*STP-209-1(2) Roadway and BHF-209-1(3) Bridge  
Widening of SR 74 From SR 85 to*

*P.I. Nos. 322355 and 322357*

**Value Engineering Study Report**

Preliminary Design Stage

ALTERNATIVE No. 8 ORIGINAL DESIGN SHEET 2 OF 9

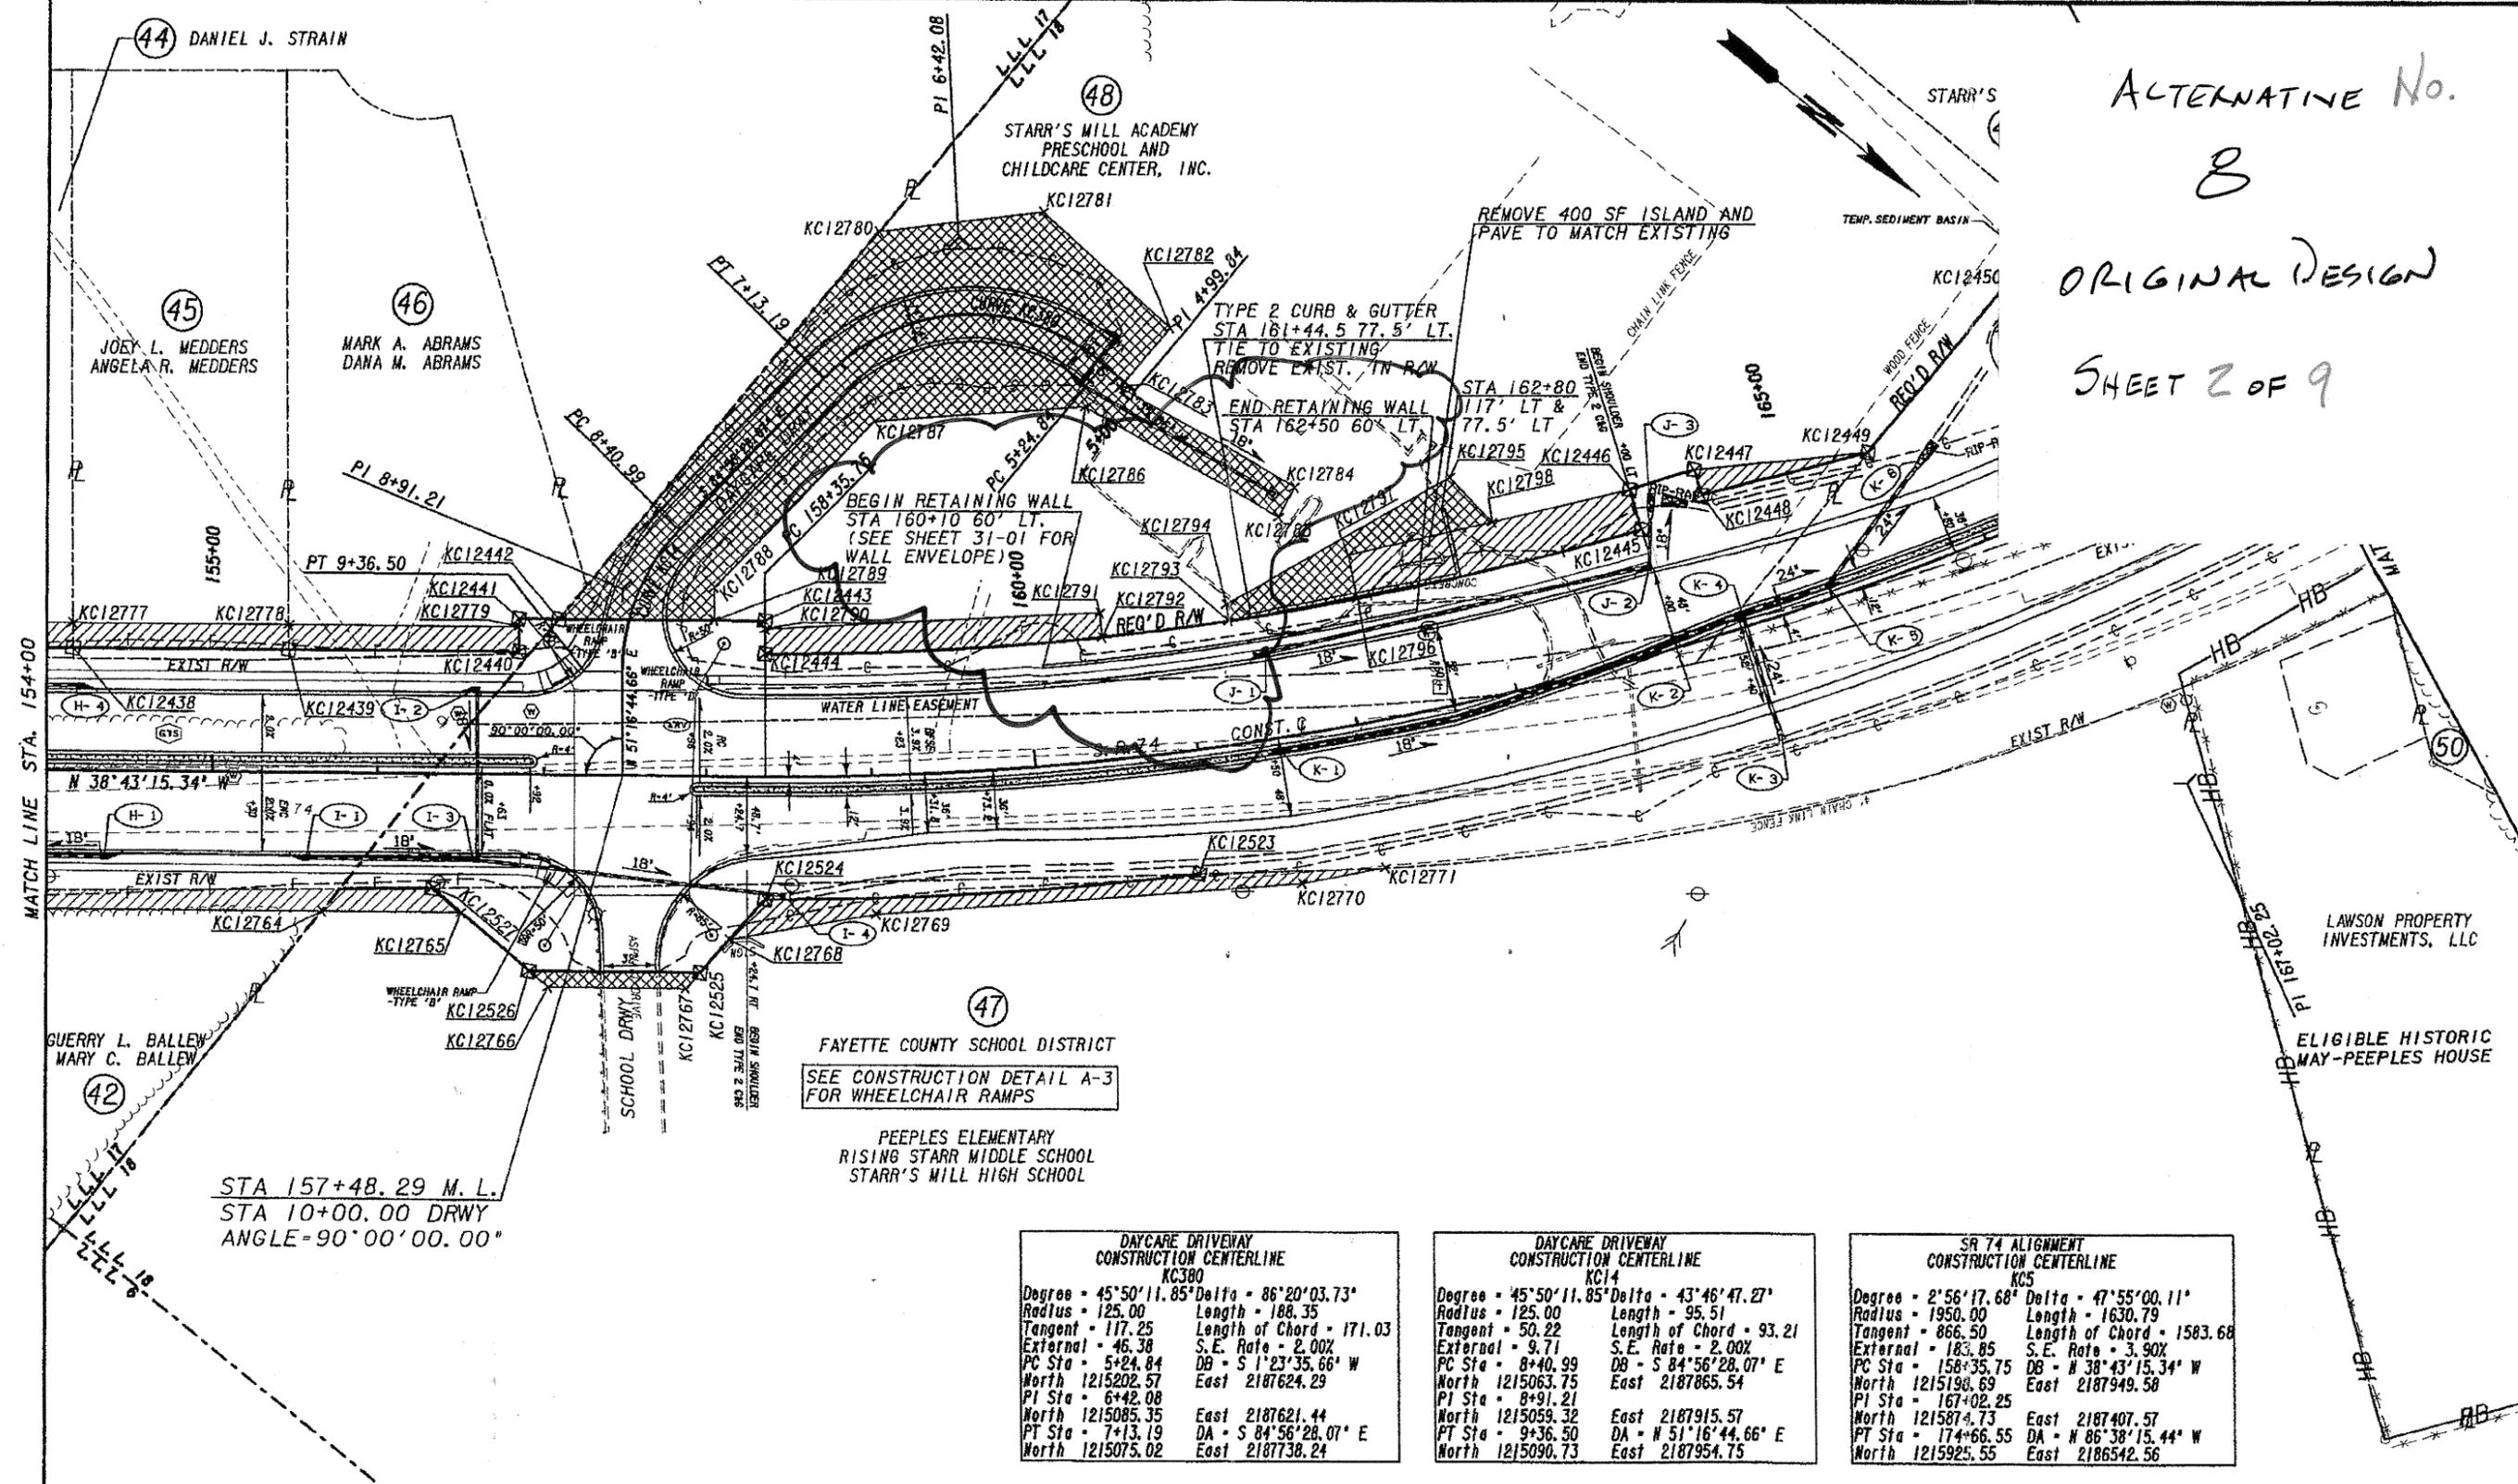
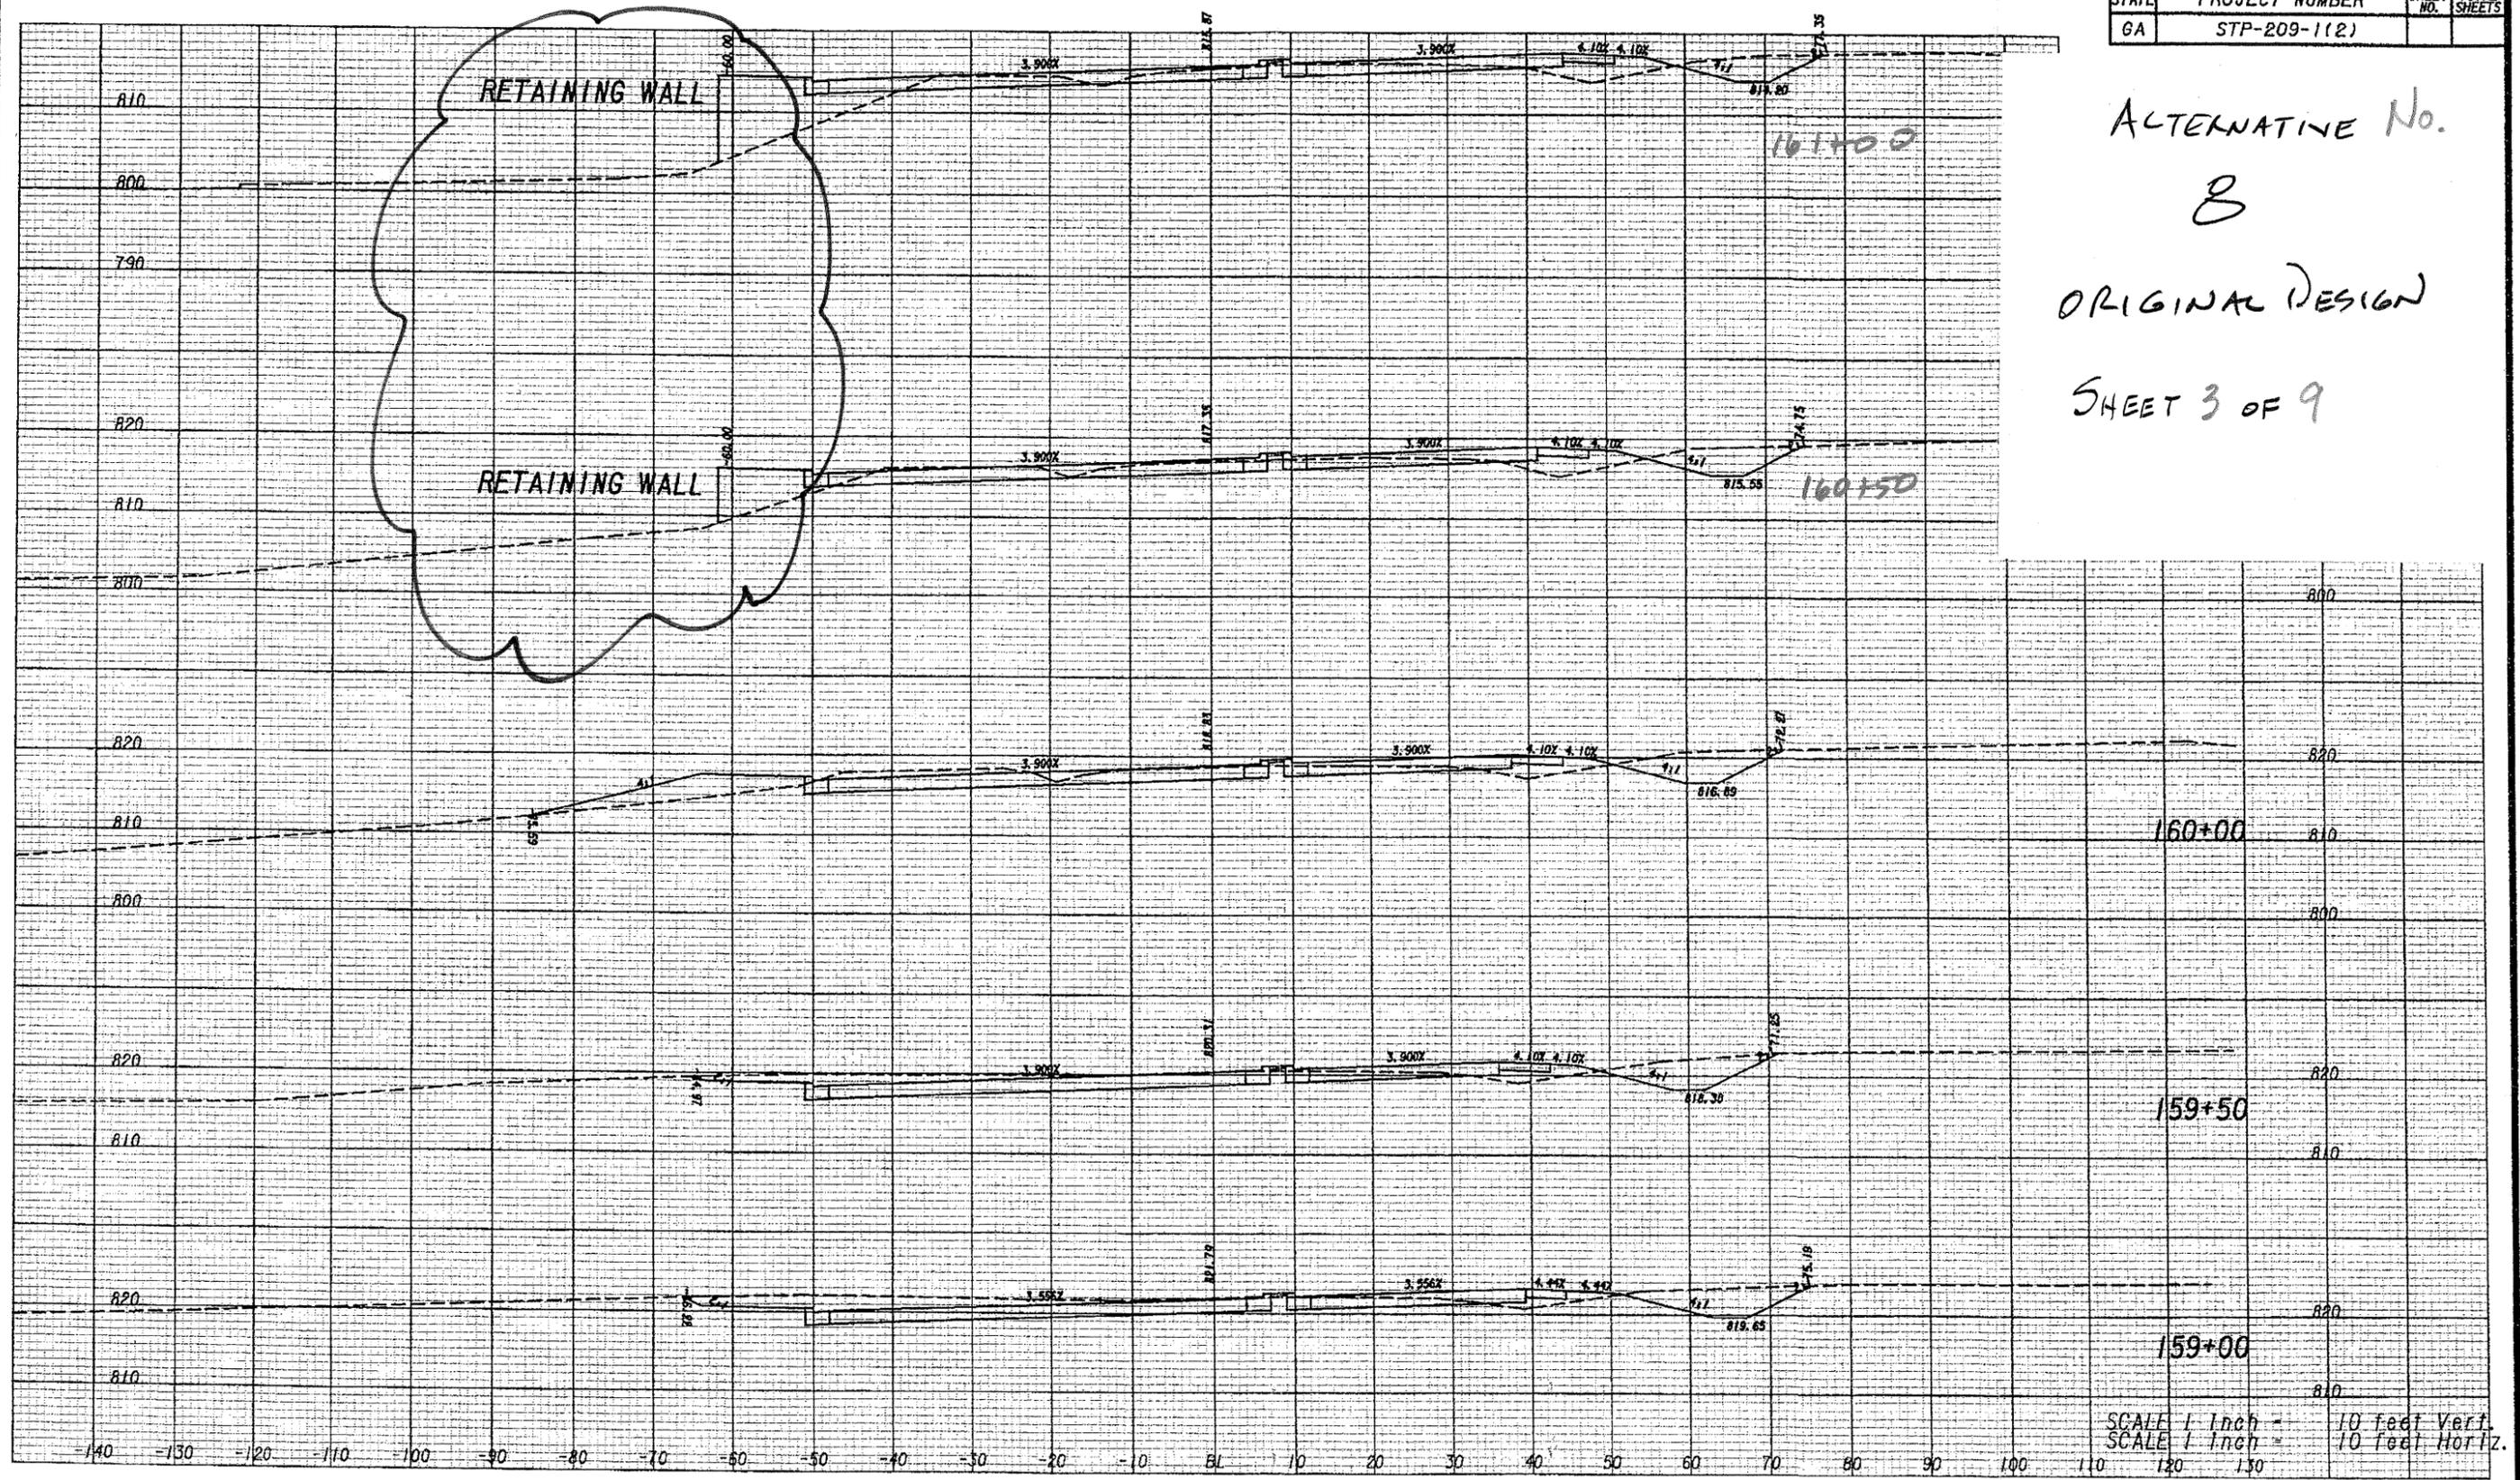
DESCRIPTION: **ELIMINATE THE RETAINING WALL AND PROVIDE** SHEET NO.: **1 of 9**  
**ADDITIONAL DAYCARE PARKING**

Replace the retaining wall with a 2:1 fill slope and provide five additional parking spaces.

PROVIDE  
5 PARKING  
SPACES
